AA.23.19.09 Immingham Green Energy Terminal

Prepared for:	Becky Garrett
Prepared by:	Harry Robinson (SYSTRA)
Date:	16 th November 2023
Case Reference:	DevHU0144
Document Reference:	AA.23.19.09 Technical Memorandum
Reviewed/approved by:	Terry Dale (SYSTRA)

Figure 2. Collisions at A180 / A1173 2015-2022 (source: CrashMap)

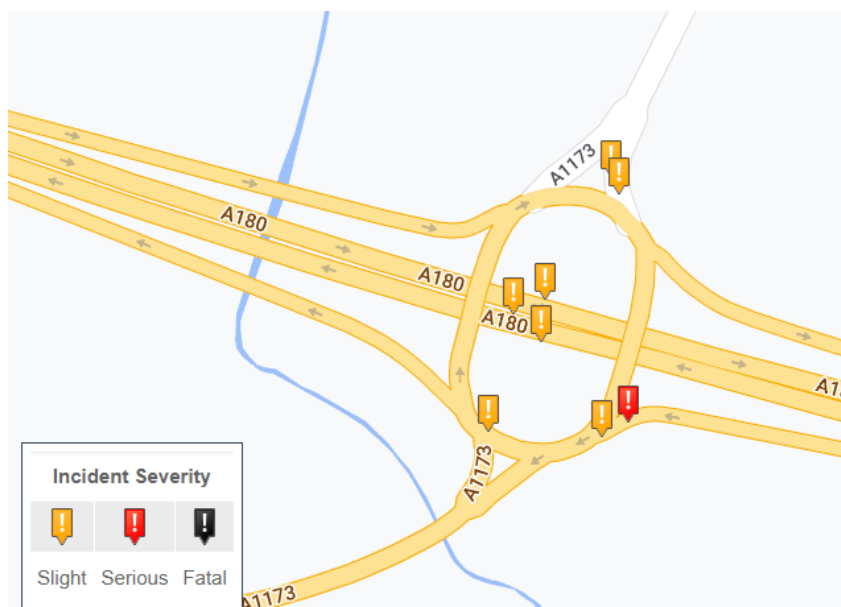
JSJV would consider it inappropriate to use 2020 and 2021 data for this analysis because the traffic flows during these years were materially influenced by the COVID19 pandemic. However, as can be seen from **Figure 2**, JSJV would agree that there has been a relatively small number of collisions at the junction from 2015-2022. Consequently, we do not consider there to be a pre-existing highway safety issue at the A180/A1173 junction; we do note nonetheless, the occurrence of a serious incident on the westbound off slip.

Figure 5. A180 average daily flow between October 2022 and May 2023 (weekdays only)

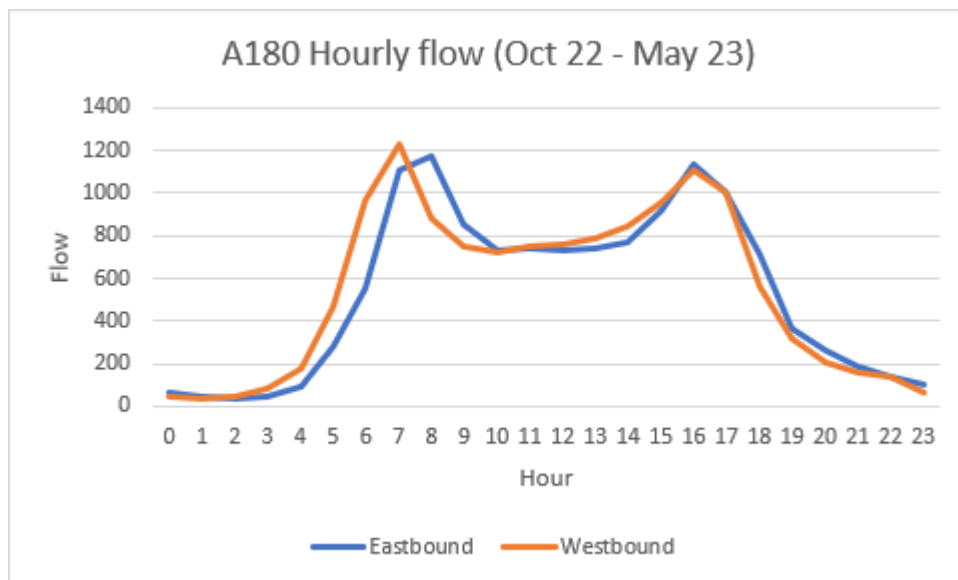
JSJV has reviewed WebTRIS data for the A180 to confirm whether or not 08:00-09:00 and 17:00-18:00 is the weekday peak periods, as shown in **Figure 5**. The data was extracted from the WebTRIS count point on the A180 to the east of the A180/A160 junction and west of the A180/A1173 junction.

As can be seen from **Figure 5**, JSJV would consider 07:00-08:00 and 16:00-17:00 as more appropriate weekday peak hour periods than 08:00-09:00 and 17:00-18:00 for the SRN.

- After a review of WebTRIS data for the A180, JSJV would consider 07:00-08:00 and 16:00-17:00 as more appropriate weekday peak hour periods than 08:00-09:00 and 17:00-18:00 for the SRN.

Figure 7. ABP construction worker trip distribution

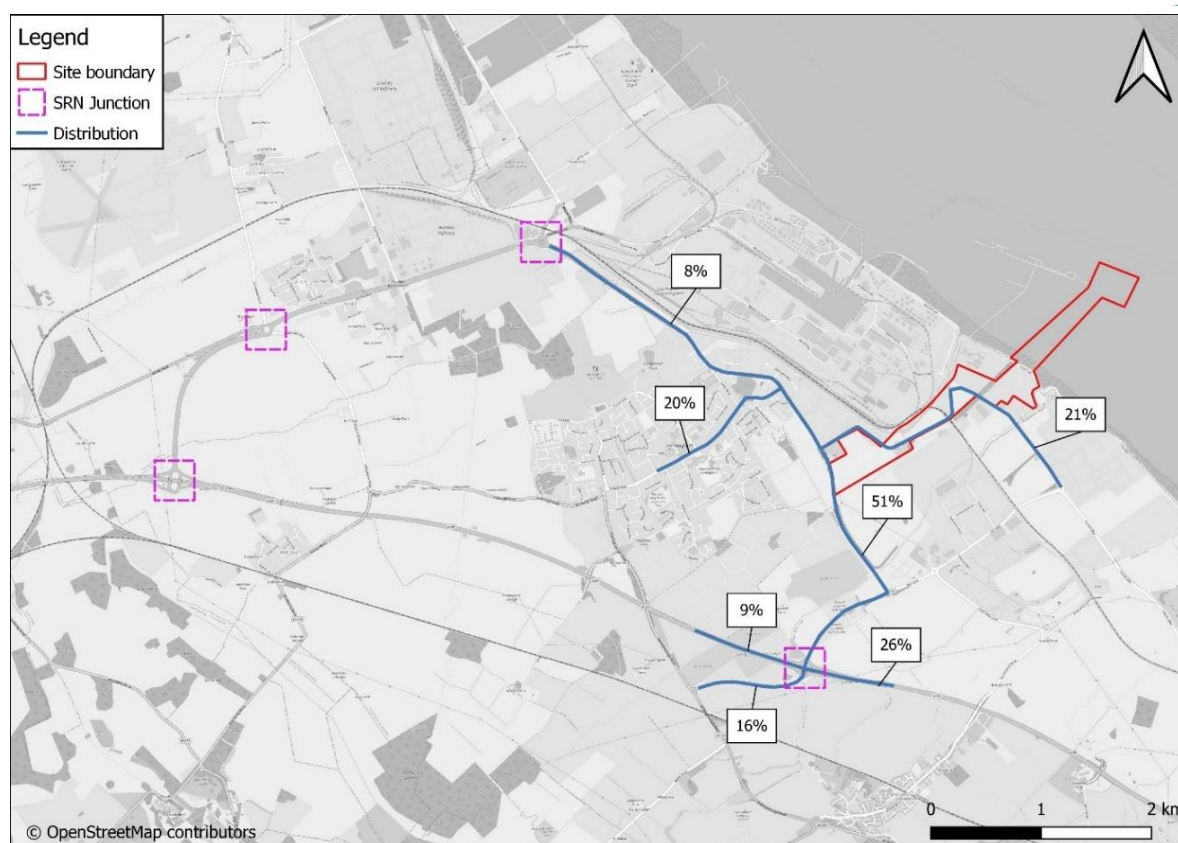
JSJV has presented the distribution shown in **Figure 6** on the local network shown in **Figure 7**.

JSJV would note that the distribution and assignment shown in **Table 2** is different to the ABP distribution and assignment within the Traffic and Transport chapter. As shown in **Figure 8**, JSJV would note that ABP has incorrectly presented the number of workers per vehicle.

As can be seen in **Figure 8**, for the PM, ABP has multiplied the workers trips by what seems to be 1.2 instead of dividing by 1.5; subsequently, this would equate to more cars per worker rather than 1.5 workers per car.

JSJV would recommend that ABP reviews its construction worker vehicle distribution and presents the results on flow diagrams.
